SUBJECT: Revisions to Jurisdictional Waters for the Genesis Solar Energy Project

Revisions to Jurisdictional Waters
Genesis Solar Energy Project
March 13, 2010

Appendix C. Washes and Microphyll Vegetation Directly Impacted by Project Facilities

**WATERS EVALUATION
SHEET 4**

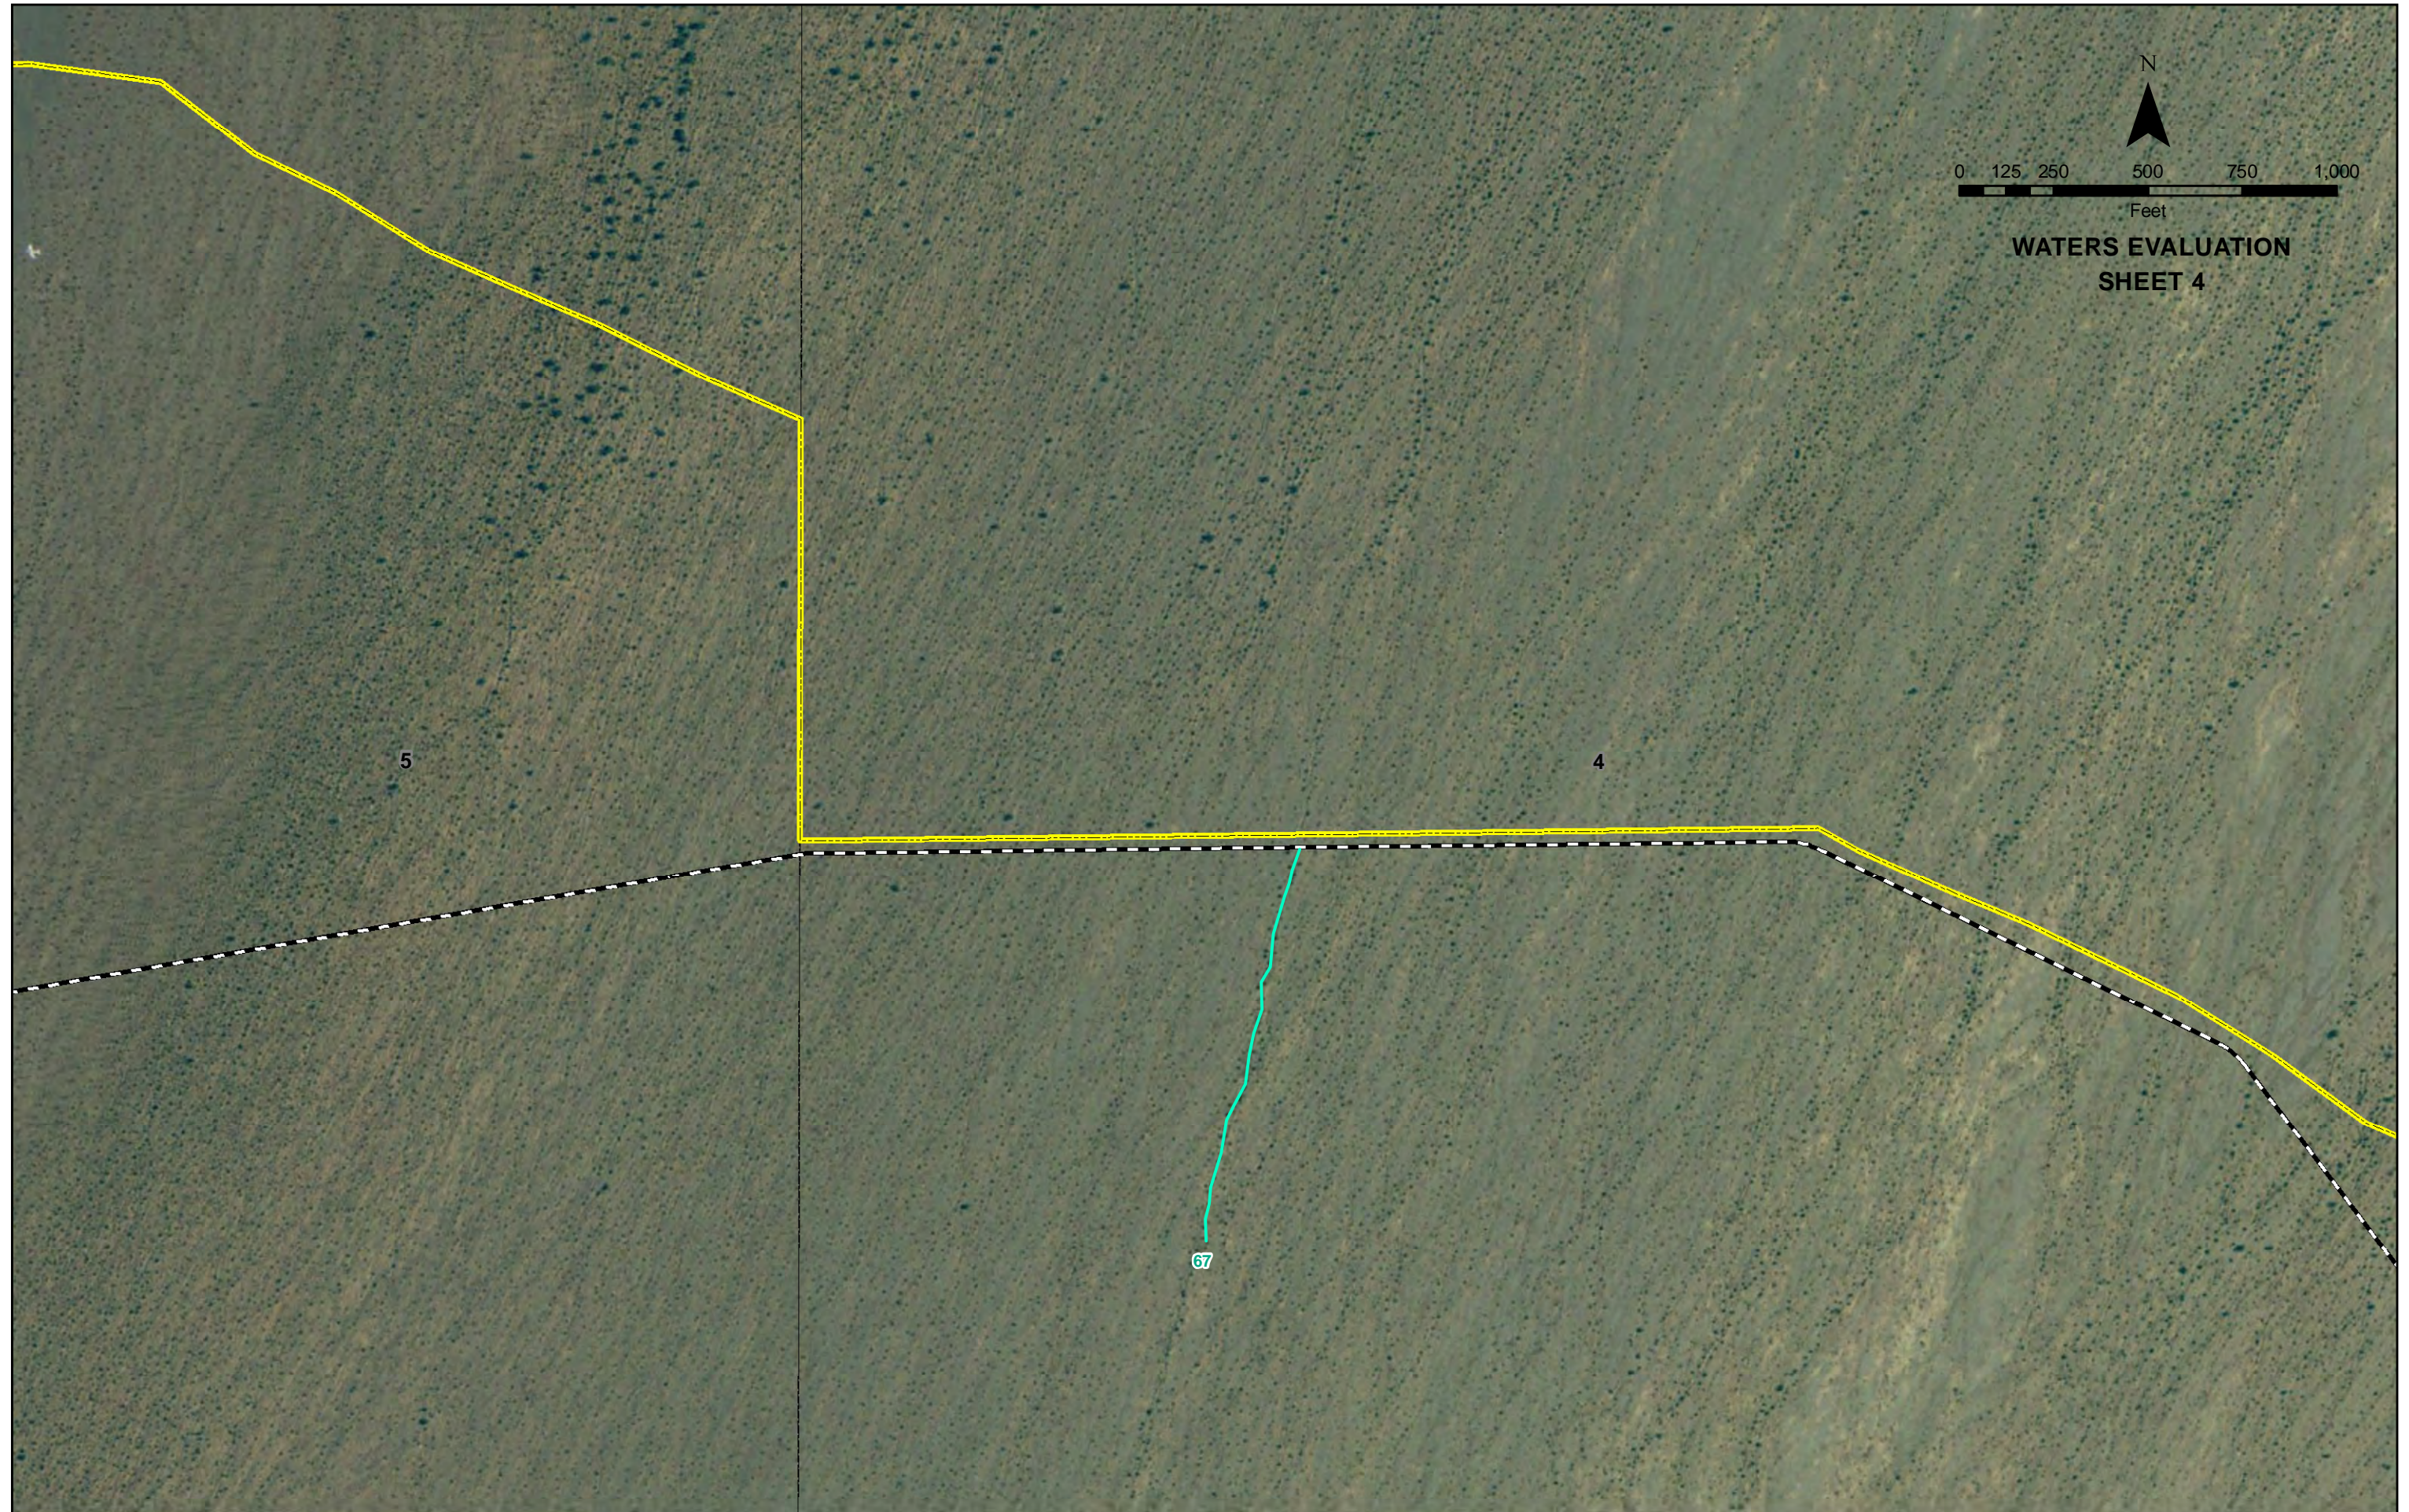
Per your request, Genesis Solar has revised the appropriate table and figures to depict the drainages you delineated in the field on February 17, 2010. Specifically, updates have been made to Appendix C. *Washes and Microphyllous Vegetation Directly Impacted by Project Facilities* and Map Sheets 2, 4, 5, 11, and 12 of the *Jurisdictional Waters and Wetlands Report* submitted in January 2010. The added drainages result in an additional 7.80 acres of permanent impact, 0.00 acres of temporary impact, 2 additional impacted trees (ironwood trees), and 0.00 acres of microphyll vegetation areas. The area permanently impacted by the Project is now 72.64 acres.
